South Texas Project
Units 3 and 4
Docket Nos. 52-012 and 52-013
Response to Request for Additional Information

RAI 06.02.01.01.C-11**QUESTION**

Figure 1 Long-Term FWLB Drywell Pressure

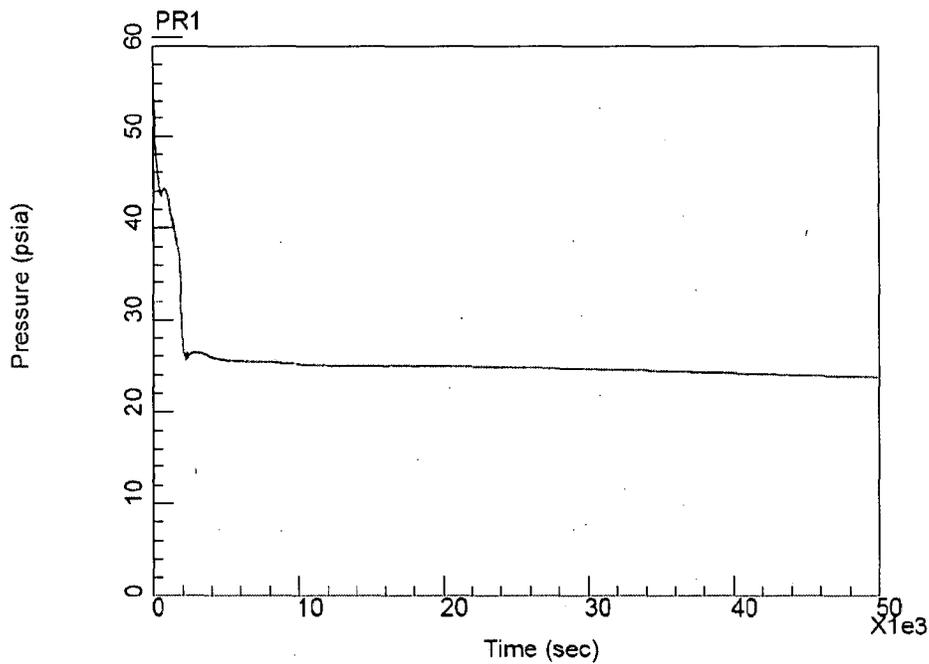
Provide the results of containment pressure and temperature analysis (WCAP-17058-P) for the long term Feed Water Line Break (FWLB) simulation. Provide the mass and energy release rate to containment and the ECCS flow rate from the suppression pool for this scenario.

The long-term feedwater line break (FWLB) peak pressure and temperature responses are shown in Figures 1 through 5. For the peak suppression pool plot (Figure 5), the solid line represents the liquid temperature in the suppression pool only (wetwell only). The dashed line represents the combined energy of the liquid in the wetwell and lower drywell, divided by the total mass of liquid. The dashed line is the reported peak suppression pool temperature.
